Digital Fault Recorder – RPV 311

HW-E, FW 15A00.00

Product Notification

GE Vernova Publication Number: GET-20116

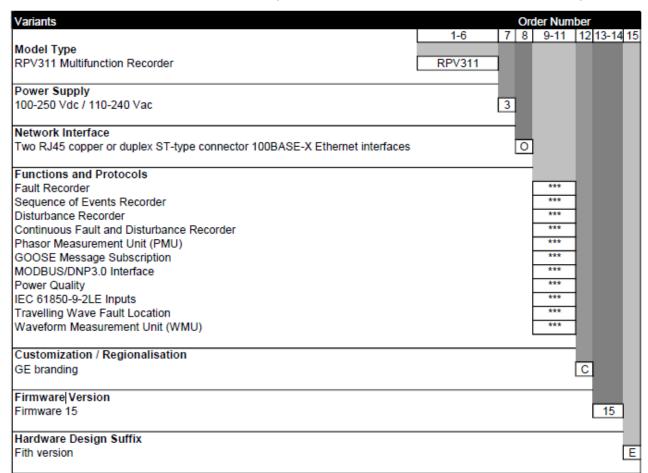
The redesigned RPV-311 Hardware and Firmware are mechanically and electrically compatible with existing and previous RPV-311.

HW-E keeps all previous RPV-311 features except the ones related to console ports described above.

HW-E is only compatible with FW 15A00.

FW-15A00 enhances cyber security and monitoring functions while keeps all previous FW-14A00 features except the ones related to Flash Player Web configurator described above.
